Access Compliance Report Public Rights-of-Way (Curb Ramps)

Main Street: BRIMHALL_DR Cross Street: MARTHA_ANN_DR Location: SE

ADA ID: RPRK211207115945 Ramp Type: Type 1 - Perpendicular Diagonal Initial Pass/Fail: Pass Overall Compliance: No Severity Score: 17

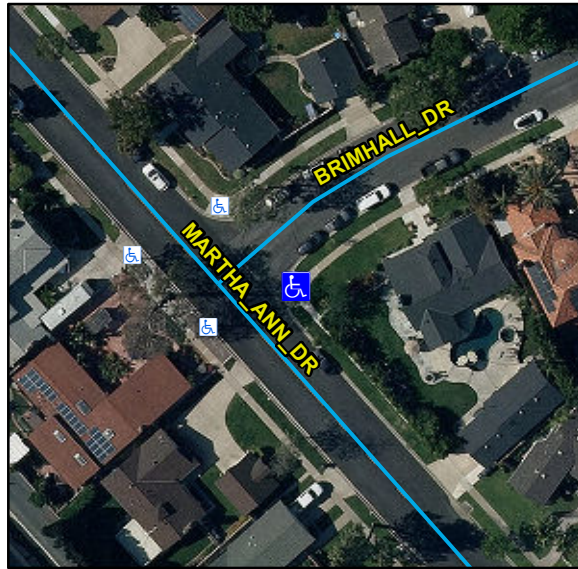
Compliance	Description	Data	Compliance	Description	Data
N/A	Ramp Length (in)	76	N/A	Flare Type LT	
Yes	Ramp Width (in)	48			Sloped
Yes	Ramp Run Slope (%)	5.2	N/A	Flare Slope LT (%)	5.7
No	Ramp Cross Slope (%)	2.3	N/A	Flare Traversable LT	No
N/A	Landing Present	Yes	N/A	Flare Type RT	
N/A	Landing Length (in)	48			Sloped
Yes	Landing Width (in)	48	N/A	Flare Slope RT (%)	8.7
Yes	Landing Run Slope (%)	0.6	N/A	Flare Traversable RT	No
No	Landing Cross Slope (%)	4	No	DWS Provided	No
N/A	Landing Movement Obstructed?	No	N/A	DWS Contrast	N/A
	Landing Movement Type	N/A	N/A	DWS Length (in)	N/A
N/A	Landing Shared	No	N/A	DWS Full Width	N/A
N/A	Clear Space	Yes	N/A	DWS Offset Left (in)	N/A
N/A	Clear Space To Crosswalk (in)	48	N/A	DWS Offset Right (in)	N/A
N/A	Marked Crosswalk 1	No	N/A	Marked Crosswalk 2	No
	Crossing 1 Direction	N		Crossing 2 Direction	W
	Marked Crosswalk 1 Width (in)	N/A		Marked Crosswalk 2 Width (in)	N/A
N/A	Ramp Inside Crosswalk 1	N/A	Yes	Ramp Inside Crosswalk 2	N/A

Crossing 1 Slope (%)	6.7		Crossing 2 Slope (%)	2.6
	Crossing 1 Cross Slope (%)	2.7		Crossing 2 Cross Slope (%)	1.4
Yes	Gutter Ponding	No	No	Curb Slope	7.5
Yes	Gutter Lip Height (in)	0		Road Run Slope (%)	1.4
No	Gutter Run Slope (%)	8.5		Road Cross Slope (%)	6.4
Yes	Gutter Cross Slope (%)	1.4			
Yes	Overall Surface Condition: Acceptable		No	Perp Joint Present	No
	Cross Gutter Present?	No		Spandrel Present?	No
	Replace Cross Gutter?	N/A		Replace Spandrel?	N/A

Remove & Replace Curb Ramp With Two New Directional Ramps or Equivalent. Remove & Replace Gutter.

R304.2.2, R204.3, R304.5.3, R305, R304.5.4, STD 1115
